SITE PLAN & ARCHITECTURAL COMMISSION AGENDA FEBRUARY 16, 2018

Site Plan and Architectural Commission

Agenda

- 50.1 AC-17-144 Consideration of a proposal for the development of a single 0.85-acre lot, consisting of the construction of a 2,300 square foot fast food restaurant located at 2233 Biddle Road in the Regional Commercial (C-R) zoning district (371W18C1205); (Oregon Architecture, Inc., Applicant; Dustin Severs, Planner).

PROPOSED SITE PLAN

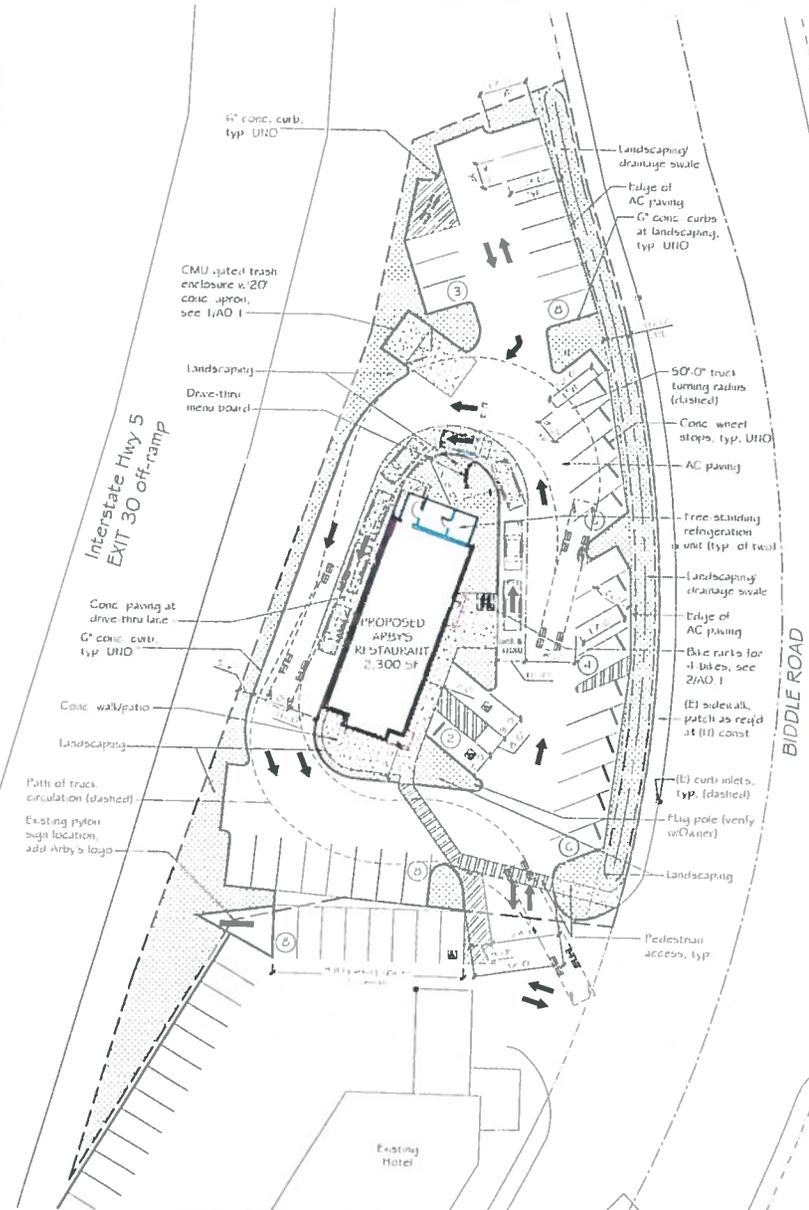
The submitted site plan identifies a total of 30 proposed parking spaces - plus 8 existing spaces shared with the adjacent Shilo Inn motel - meeting the minimum required spaces for the site per MLDC 10.741. Additionally, the site plan includes the requisite number, location, and dimensions of accessible parking spaces and bicycle parking spaces as outlined in the Code.

Access to the subject site will be provided by an existing driveway located to the south of the site, which will be shared with the abutting Shilo Inn. The submitted site plan shows all vehicle travel moving in one counter-clockwise direction, looping from the entrance around the building and exiting through the same access point.

While the applicant's submitted site plan shows pedestrian walkways, the site plan does not demonstrate compliance with the design standards pursuant to MLDC 10.775(2) cited above. As a condition of approval, the applicant will be required to submit a revised site plan with their building permit submittals illustrating a pedestrian walkway design consistent with the design standards found in MLDC 10.775(2).

The submitted site plan (Exhibit B) identifies a CMU gated trash enclosure located to the north of the site and includes an elevation drawing showing the trash receptacle concealed behind a 17'-4" x 10'-8" foot concrete masonry wall (5'8" in height) with a metal gate fence, consistent with the requirements found in MLDC 10.781.

Staff is supportive of the applicant's request to be approved for up to 16 seats on the restaurant's exterior patio, as it is staff's view that the submitted site plan shows sufficient space to accommodate the additional seating.

An error in the submitted application was identified in an email received by staff, noting that the address of the site is 2233 Biddle Road, not 2111 Biddle Road as identified on the submitted site plan. This correction will be made with the applicant's building permit submittals.

1. Comply with all conditions stipulated by the Public Works Department (Exhibit I).
2. Comply with all conditions stipulated by the Medford Water Commission (Exhibit J).
3. Comply with all requirements of the Oregon Department of Transportation (ODOT) (Exhibit L).
4. Submit a revised site plan with the building permit submittals illustrating a pedestrian walkway design consistent with the design standards found in MLDC 10.775(2).
